TEMPORARY REVISION

AMM-TR-OÄM 42-398

Artex ELT 1000

This Temporary Revision AMM-TR-OÄM 42-398 is approved in conjunction with the Optional Design Change Advisory OÄM 42-398 and is valid in conjunction with the Airplane Maintenance Manual (AMM) until this Temporary Revision has been incorporated into the AMM.

Figure 7: Artex ELT 1000 Installation

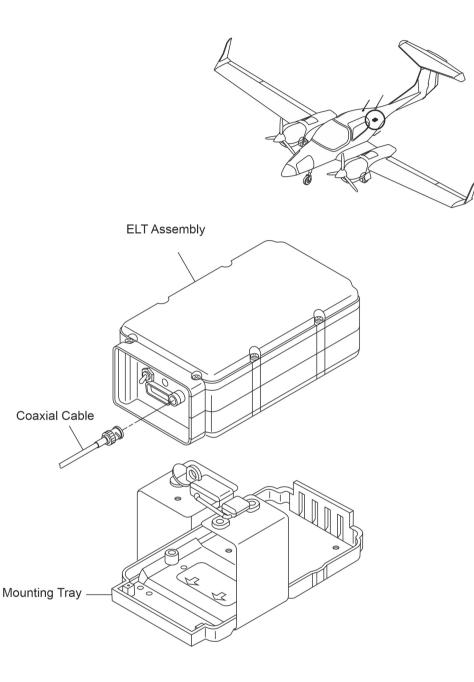
The following figure is added:
